# Ancient City of Damascus (Syria) No 20

# Date of ICOMOS approval of this report

## 2. Issues raised

Map showing the boundaries of the proposed buffer zone

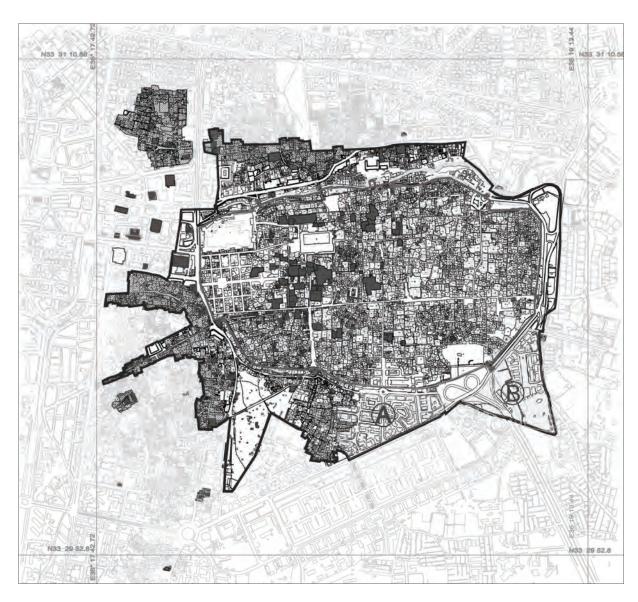
ICOMOS considers the fact that a duly mapped buffer zone has been officially approved by the State Party is a positive step. The buffer zone includes protective elements which refer explicitly to the outstanding universal value of the property and the importance of its conservation. The general provisions are supplemented by the announcement of projects affecting specific quarters or zones. ICOMOS considers that the World Heritage Committee should be kept regularly informed about the progress of such projects.

While the whole of the city walls which define the limits of the property are now surrounded by a clearly defined buffer zone, a significant proportion of the historic quarters outside the walls are not included in the zone, even though the Committee has on many occasions drawn the State Party's attention to their importance, and to the need to link them with the property itself. ICOMOS therefore considers that the proposed buffer zone is an important step in the protection of the immediate environment of the property and its landscapes, but that the State Party must continue its efforts and reflection in this matter.

ICOMOS recommends that the proposed buffer zone for the Ancient City of Damascus, Syrian Arab Republic, be approved.

- Consider extending the buffer zone as currently defined so as to ensure a better connection between the historic quarters of the ancient city and the inscribed property;
- Continue the regulation and control efforts, either currently under way or announced, for the various parts of the buffer zone, and to keep the World Heritage Committee up to date with progress in this matter.
